Access Compliance Report Public Rights-of-Way (Curb Ramps)

Main Street: SE_SKYLINE_DR Cross Street: RED_HILL_AVE Location: NE

ADA ID: RPRK211012113809 Ramp Type: Type 1 - Perpendicular Diagonal Initial Pass/Fail: Pass Overall Compliance: No Severity Score: 5

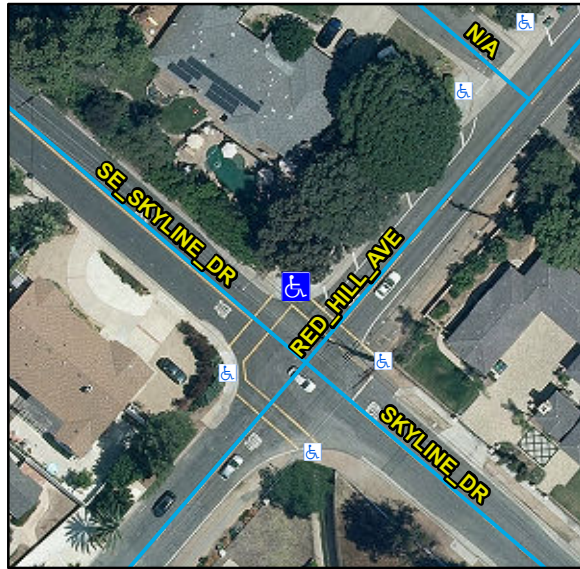
Compliance	Description	Data	Compliance	Description	Data
N/A	Ramp Length (in)	120	N/A	Flare Type LT	
Yes	Ramp Width (in)	48			Sloped
Yes	Ramp Run Slope (%)	7.2	Yes	Flare Slope LT (%)	5.9
Yes	Ramp Cross Slope (%)	0.6	N/A	Flare Traversable LT	Yes
N/A	Landing Present	Yes	N/A	Flare Type RT	
N/A	Landing Length (in)	50			Sloped
Yes	Landing Width (in)	48	Yes	Flare Slope RT (%)	4.4
Yes	Landing Run Slope (%)	1.4	N/A	Flare Traversable RT	Yes
Yes	Landing Cross Slope (%)	1.1	Yes	DWS Provided	Yes
N/A	Landing Movement Obstructed?	Yes	Yes	DWS Contrast	Yes
	Landing Movement Type	Curb	Yes	DWS Length (in)	36
N/A	Landing Shared	No	Yes	DWS Full Width	Yes
Yes	Clear Space	Yes	Yes	DWS Offset Left (in)	0
Yes	Clear Space To Crosswalk (in)	48	Yes	DWS Offset Right (in)	N/A
N/A	Marked Crosswalk 1	Yes	N/A	Marked Crosswalk 2	Yes
	Crossing 1 Direction	SW		Crossing 2 Direction	SE
	Marked Crosswalk 1 Width (in)	144		Marked Crosswalk 2 Width (in)	120

Yes	Ramp Inside Crosswalk 1	Yes	Yes	Ramp Inside Crosswalk 2	Yes
	Crossing 1 Slope (%)	7.5		Crossing 2 Slope (%)	6.6
	Crossing 1 Cross Slope (%)	2.1		Crossing 2 Cross Slope (%)	1.1
Yes	Gutter Ponding	No	No	Curb Slope	8.6
Yes	Gutter Lip Height (in)	0		Road Run Slope (%)	1.6
No	Gutter Run Slope (%)	10.7		Road Cross Slope (%)	5.3
No	Gutter Cross Slope (%)	2.9			
Yes	Overall Surface Condition: Acceptable		Yes	Perp Joint Present	Yes
	Cross Gutter Present?	No		Spandrel Present?	No
	Replace Cross Gutter?	N/A		Replace Spandrel?	N/A

Remove & Replace Curb Ramp With Two New Directional Ramps or Equivalent. Remove & Replace Gutter.
